**City of Bellevue
Development Services Department
Land Use Division Staff Report**

Proposal Name: Milestones Northwest Townhomes

Proposal Description: Application for design review approval to demolish two existing commercial single-story buildings located on two parcels and construct 5 townhome units in three single unit buildings and one 2unit buildings.

File Number: 19-119946-LD (Design Review)

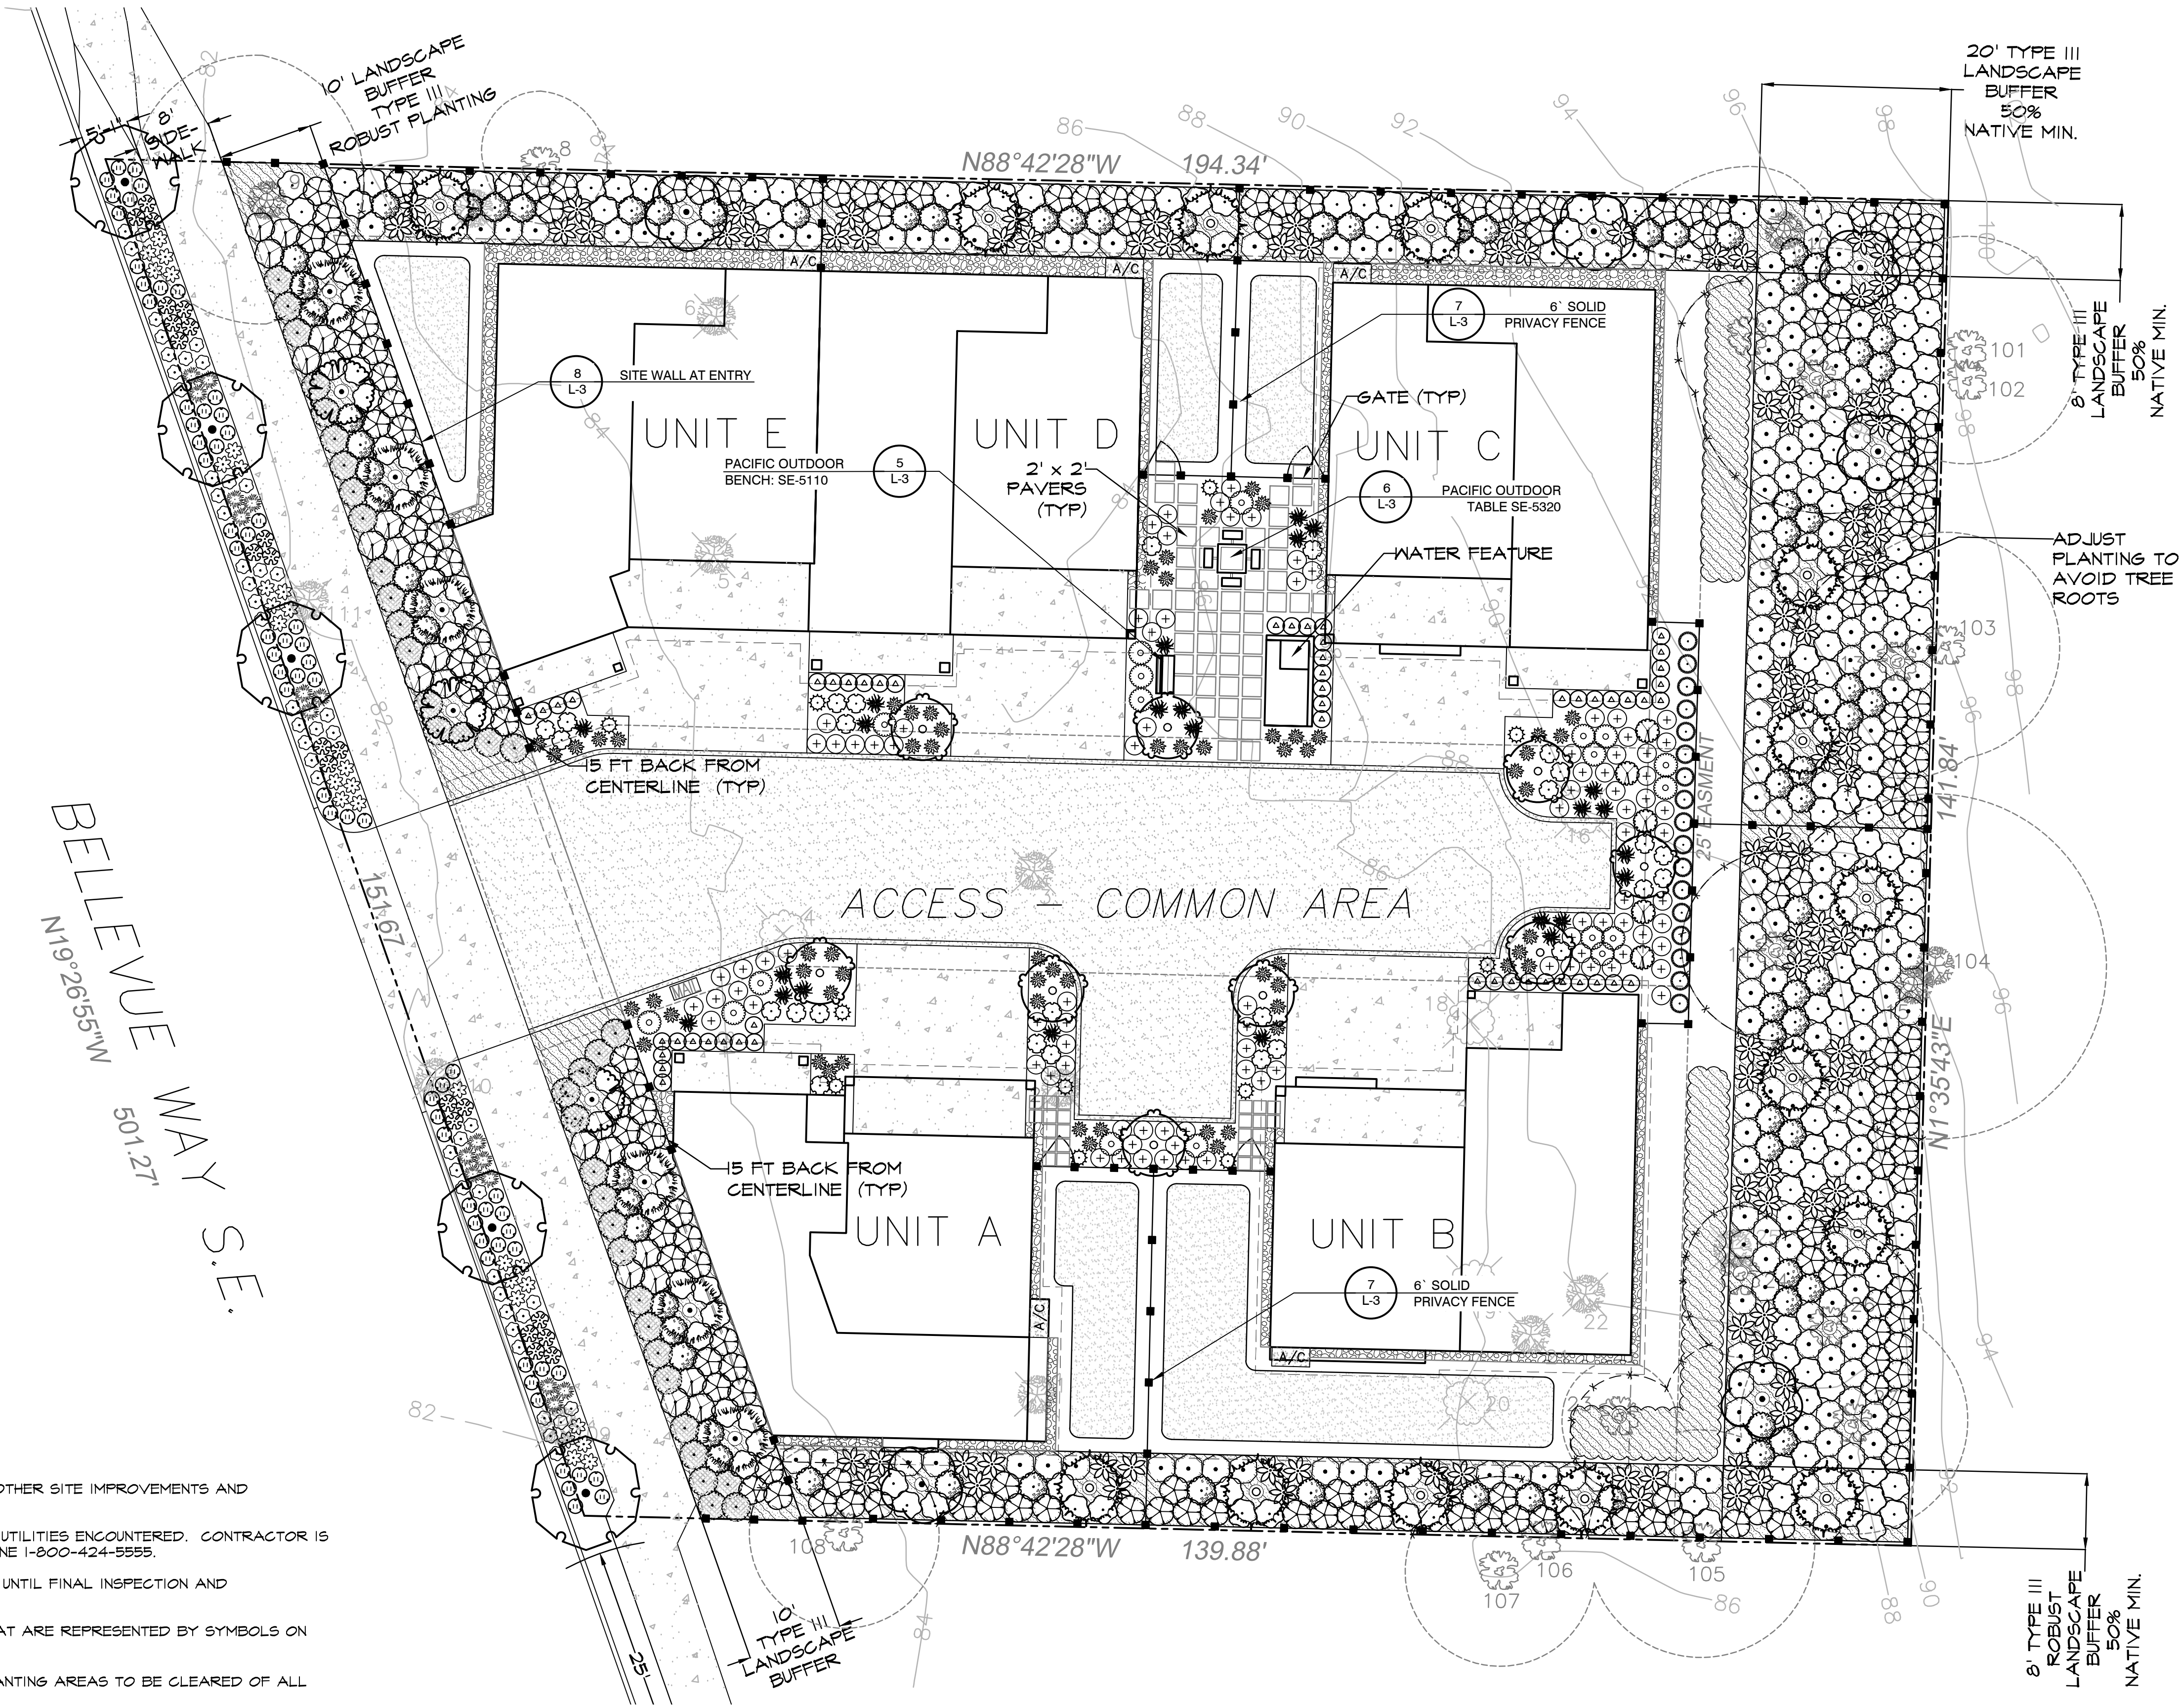
- d) Note 7 on Landscape Plan L-1 must be corrected to exclude street trees. Street trees shall be mulched uniformly with the rest of the bed as specified in Transportation detail SW-130-1.
